REGIONAL REVIEW FINDING

ARC REVIEW CODE: R1512221

Name of Proposal: Centennial Park North II

CENTENNIAL PARK NORTH II DRI – Notification Only
City of Atlanta
ARC Transportation Access & Mobility Division Review – Comments
December 21, 2015

SITE PLAN
CENTENNIAL PARK NORTH PHASE V-B
LL 79, 14TH DISTRICT, CITY OF ATLANTA, FULTON COUNTY, GEORGIA

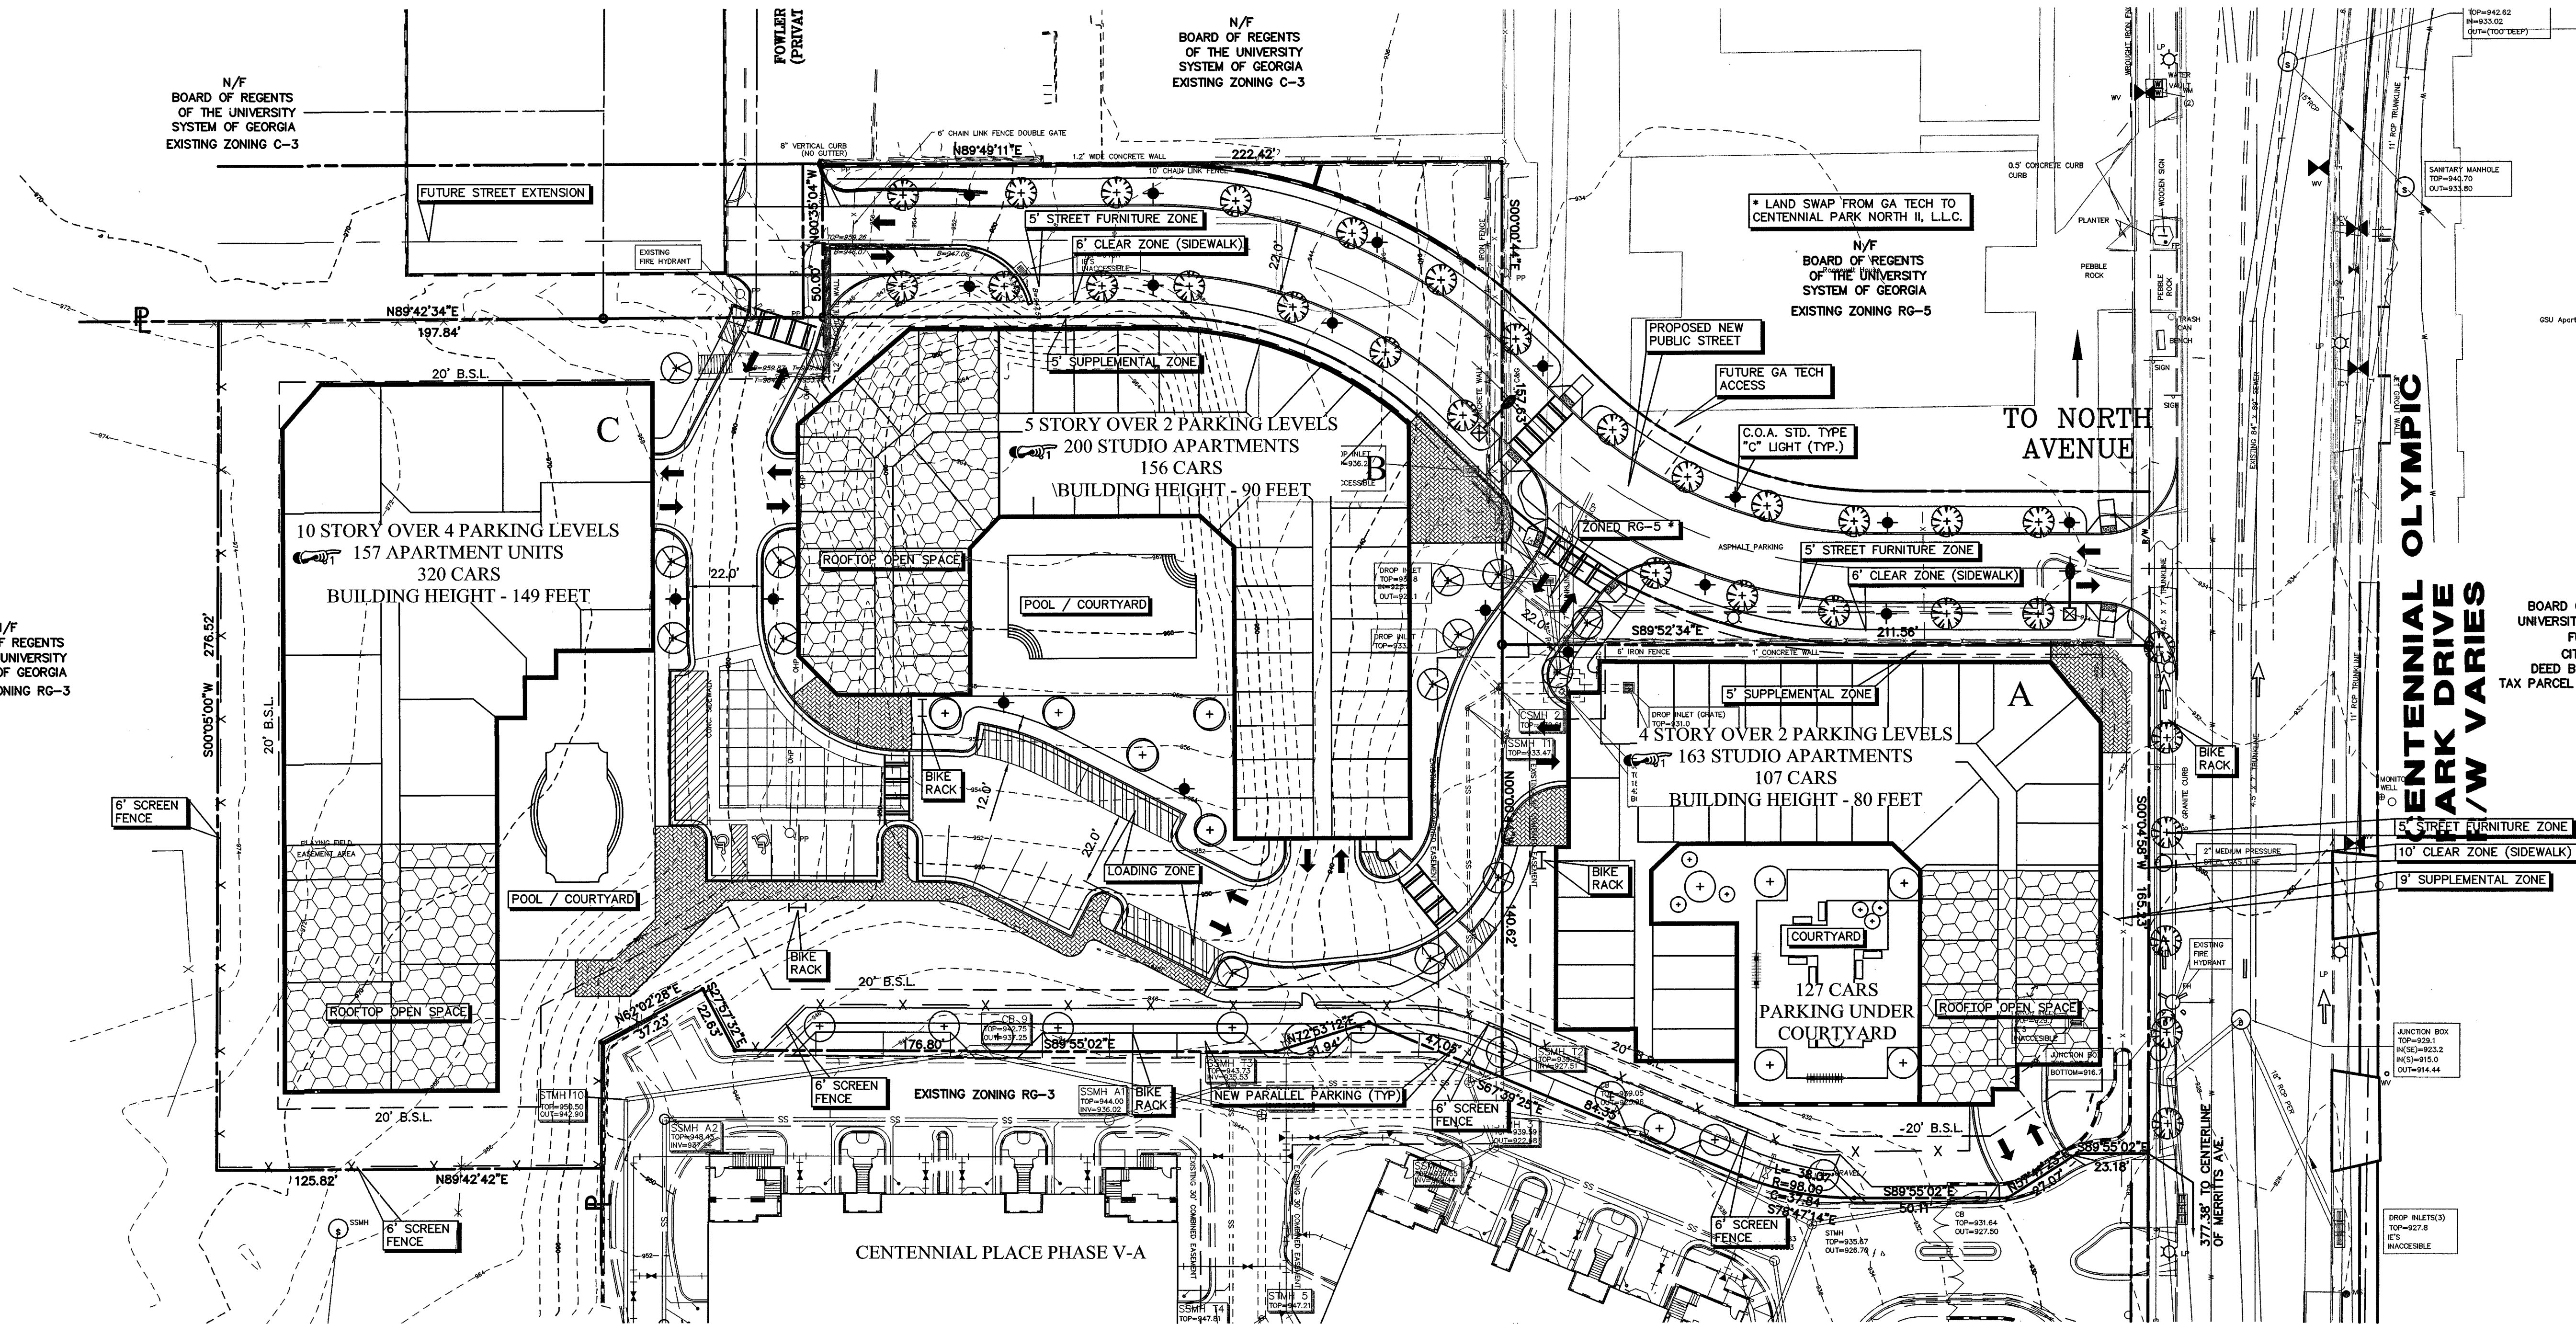
1. At the intersection of the Proposed New Public Street at Fowler Street, recommend re-designing the site driveway so it approaches the intersection at a 90 degree angle.

2. The driveway connecting from Building A to the driveway for Centennial Park North is too close to Centennial Park Drive. This driveway will create conflicts between drivers entering and exiting both developments. Additionally, vehicles exiting Building A may attempt to exit via the entrance lane for Centennial Park North. Due to these potential conflicts, recommend either removing the driveway connection between Centennial Park North and Building A or changing this driveway to entrance only for Building A.

3. At the intersection of Centennial Olympic Park Drive and the Proposed New Public Street, recommend changing the eastbound approach to two lanes – a left-turn lane and a right-turn lane. If the Proposed New Public Street lines up with the entrance driveway for the existing development on the east side of Centennial Park Drive, then recommend the eastbound approach consist of a left-turn lane and a shared through/right-turn lane.

4. At the intersection of North Avenue at Centennial Olympic Drive, recommend adding “No Right Turn on Red” signage on the northbound approach. Also recommend adding a right-turn overlap phase on the northbound approach to allow the right-turn movement during the westbound protected left-turn phase.

5. Recommend adding a loading zone for building A. There are two zones close to building B, one of which may be intended to serve building A but may not operate as intended.

6. The number of proposed parking spaces is significantly greater than the required minimum parking spaces. Recommend to reduce the number of parking spaces where possible. A clarification on the number of 1-bedroom and 2-bedroom units in building C may help.

7. Recommend adding secure and safe bike parking inside of the parking garages.
8. Recommend adding electric car charging stations for residents.
